UNITED STATES PATENT AND TRADEMARK OFFICE

APPLICATION NO.	FILING DATE	FIRST NAMED INVENTOR	ATTORNEY DOCKET NO.	CONFIRMATION NO.
10/616,287	07/09/2003	Hiroyuki Takahashi	16816	9906

Office Action Summary	Application No. 10/616,287	Applicant(s) TAKAHASHI, HIROYUKI	
	Examiner Henry M. Johnson, III	Art Unit 3739

figure 2

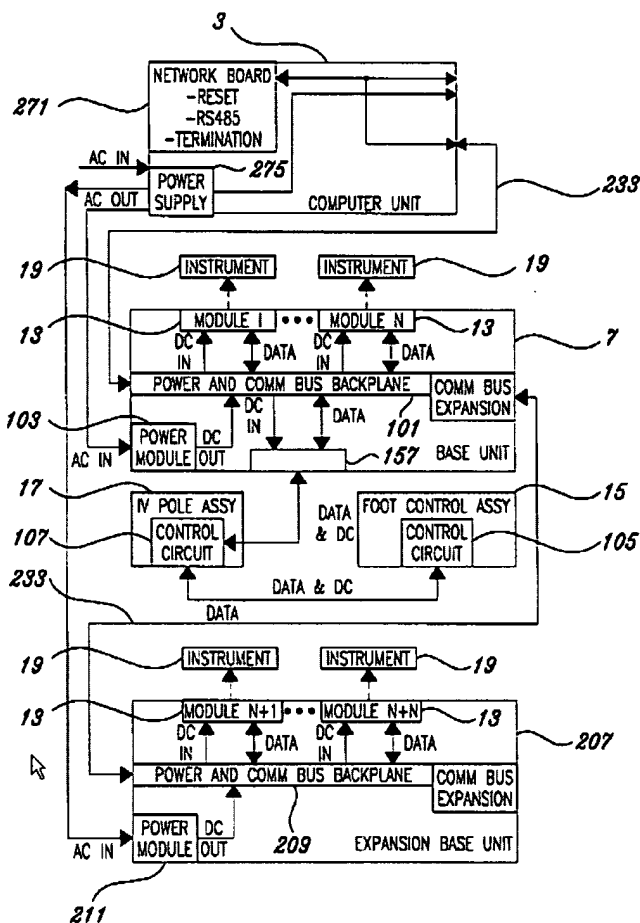
making regarding synchronization based on the program code. Panel controls (switches) or a foot switch (Fig. 2, # 15) may operate the instruments. It is inherent that the processor would know the status of the control panel switches.

Applebaum et al. teach it may be desirable to prevent certain instruments from operating simultaneously for safety reasons. For example, a phacoemulsification instrument is disabled by the bipolar coagulation instrument when the latter is being used and vice-versa. In contrast, the aspiration function is needed during phacoemulsification or phacofragmentation (Col. 18, lines 10-20). Thus, Applebaum et al. clearly teach a permission/no permission capability. The identification of each module is known to the system as are the operating parameters of the module and its instrument (Col. 20, lines 55-
